Seabrook Station
Docket No. 50-443
Renewed Facility Operating License No. NPF-86

Seabrook Station
Response to Request for Additional Information Regarding Degraded Voltage Time
Delay Setpoint License Amendment Request

Response to Request for Additional Information Regarding Degraded Voltage Time
Delay Setpoint License Amendment Request

Figure 1 - Staff Confirmatory Review

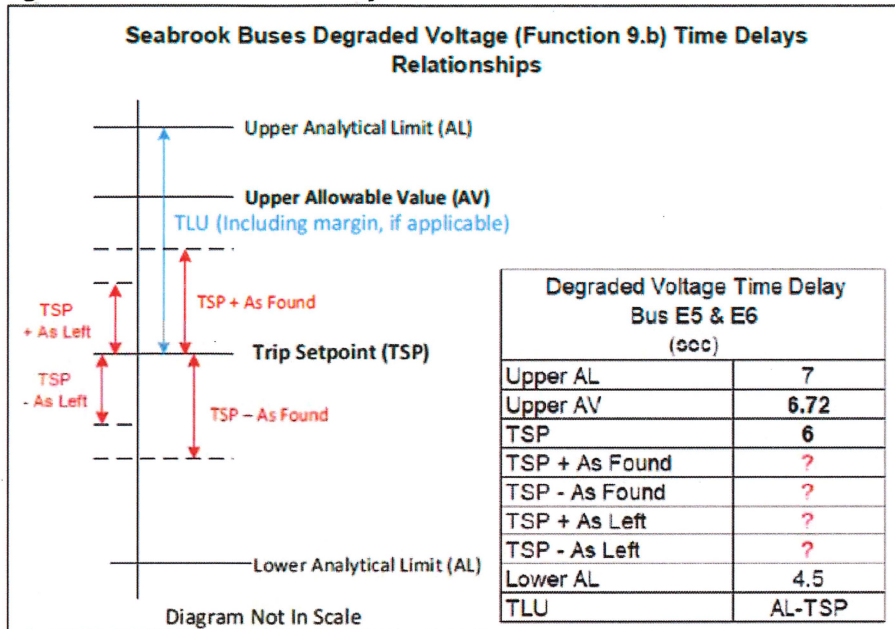
Provide a summary of the relevant calculation information that determined the new time delay setpoint for the 4.16 kV Bus 5 and 6 degraded voltage time delay relays, reducing the delay from a nominal 10 seconds (10.96 seconds allowable value) to 6 seconds (6.72 seconds allowable value). The summary should include the relay setting design basis, including the trip setpoint, the setting and tolerances to be used during calibration and required surveillances, the uncertainties associated with these settings, the expected relay drift between surveillances, measurement and test equipment uncertainties, and the as-found and as-left tolerance acceptance values to be applied during initial calibration and technical specification-related surveillances. Alternatively, the full setpoint uncertainty calculation may be provided for convenience but is not necessary.

This information is needed to enable the staff to understand the relationships among the trip setpoint, the as-left and as-found surveillance test acceptance criteria as further depicted below, in order to verify that the regulatory requirements and guidance above are being met regarding the selection and periodic surveillance of the setpoint and allowable time delay of Function 9.b. (Refer to Figure 1 below).

In the summary of the calculation, please indicate how the as-left and as-found surveillance test acceptance criteria were determined. This information is needed by the staff to evaluate whether key criteria within RIS 2006-17 are being met.

Bus 5 and 6 62D relay calibration is performed by station procedure LX0563.61, 4.16kV Bus Degraded Voltage Protection Channel Calibration and Relay PM. According to this procedure, if the as-found operate time of the 62D relay is not 5.85 to 6.15 seconds, technicians will adjust the relay as necessary to be within the acceptance criteria of 5.85 to 6.15 seconds. This acceptance criteria is chosen to be 50% of the relay accuracy of 0.3 seconds. The requested information to be included in Figure 1 is as follows:

Degraded Voltage Time Delay Bus E5 & E6 (sec)	
Upper AL	7
Upper AV	6.72
TSP	6
TSP + As Found	6.15
TSP - As Found	5.85

TSP + As Left	6.15
TSP - AS Left	5.85
Lower AL	4.5
TLU	AL-TSP
